CINEMARK GALLERIA MALL 14
1191 GALLERIA BLVD. SUITE 200
ROSEVILLE, CA 95678

Design #	0618522AR12 PERMIT
Sheet	1 of 15
Client	Cinemark USA, Inc.
Address	1191 GALLERIA BLVD. ROSEVILLE, CA 95678
Acct. Rep. Coordinator	DEBBIE MOLTZ LAUREN STACKHOUSE
Designer	IH
Date	4/23/19
Approval / Date	
Client	
Sales	
Estimating	
Art	
Engineering	
Landlord	
Revision/Date

sheet title
SITE PLAN

sheet number
A1.01

1 SITE PLAN
1/16" = 1'-0"

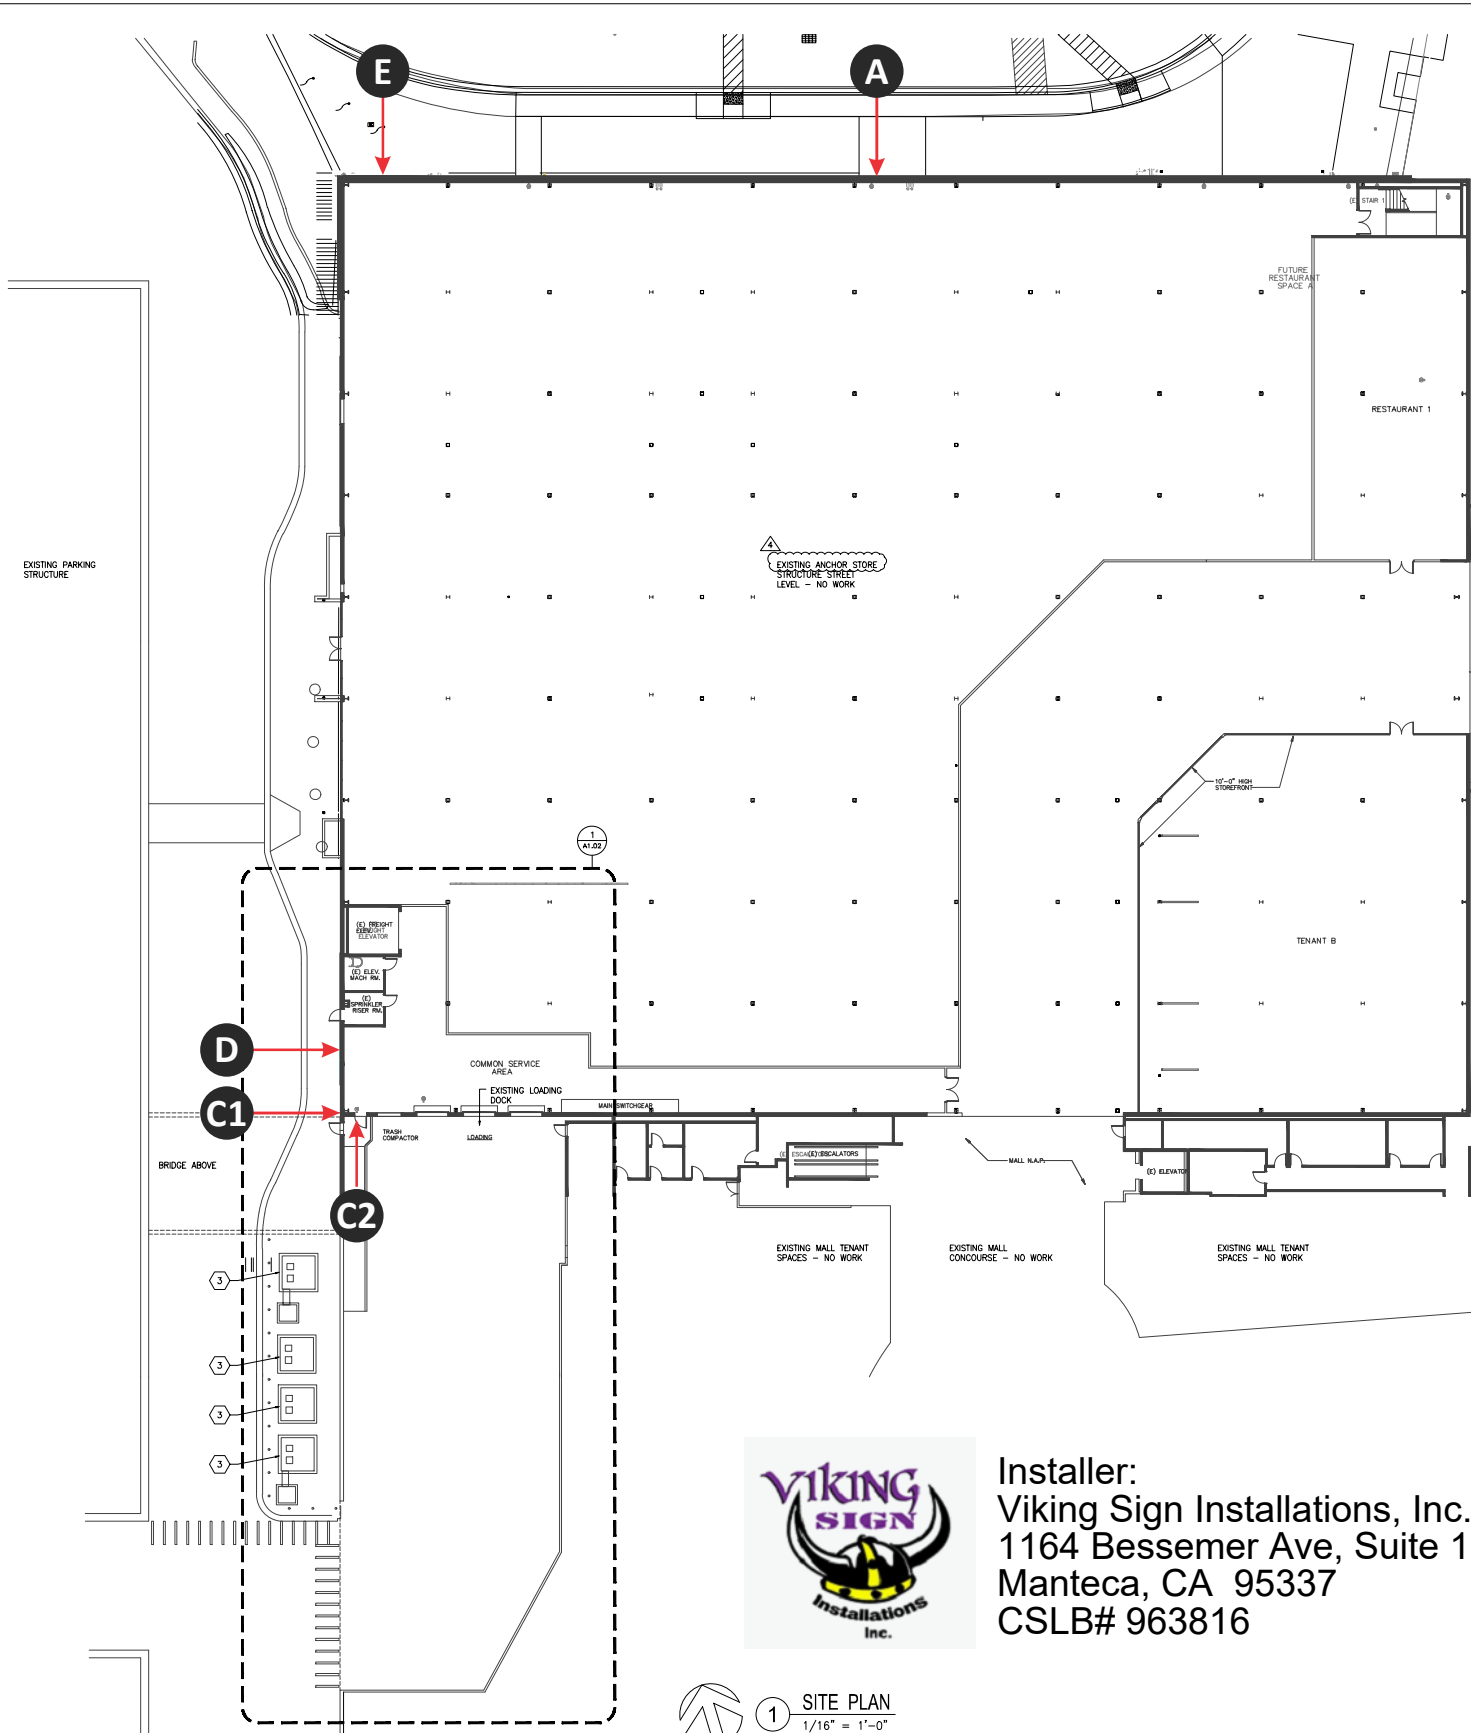
REVISION 1: Sign A - please show the blue area and white outline on the "Cinemark Theater" sign. B - please show the blue area and white outline on the "Cinemark Theater" sign. C - please show the blue area and white outline on the "Cinemark Theater" sign. D - please show the blue area and white outline on the "Cinemark Theater" sign. E - please show the blue area and white outline on the "Cinemark Theater" sign.

REVISION 2: Change 145 to just "Cinemark" without "Theater". Change 145 to be a cabinet without restrooms and just the cabinet returns out to the floor.

REVISION 3: Change 145 to be a cabinet without restrooms and just the cabinet returns out to the floor. Change 145 to be a cabinet without restrooms and just the cabinet returns out to the floor. Change 145 to be a cabinet without restrooms and just the cabinet returns out to the floor.

REVISION 4: Change 145 to be a cabinet without restrooms and just the cabinet returns out to the floor. Change 145 to be a cabinet without restrooms and just the cabinet returns out to the floor. Change 145 to be a cabinet without restrooms and just the cabinet returns out to the floor.

REVISION 5: Change 145 to be a cabinet without restrooms and just the cabinet returns out to the floor. Change 145 to be a cabinet without restrooms and just the cabinet returns out to the floor. Change 145 to be a cabinet without restrooms and just the cabinet returns out to the floor.
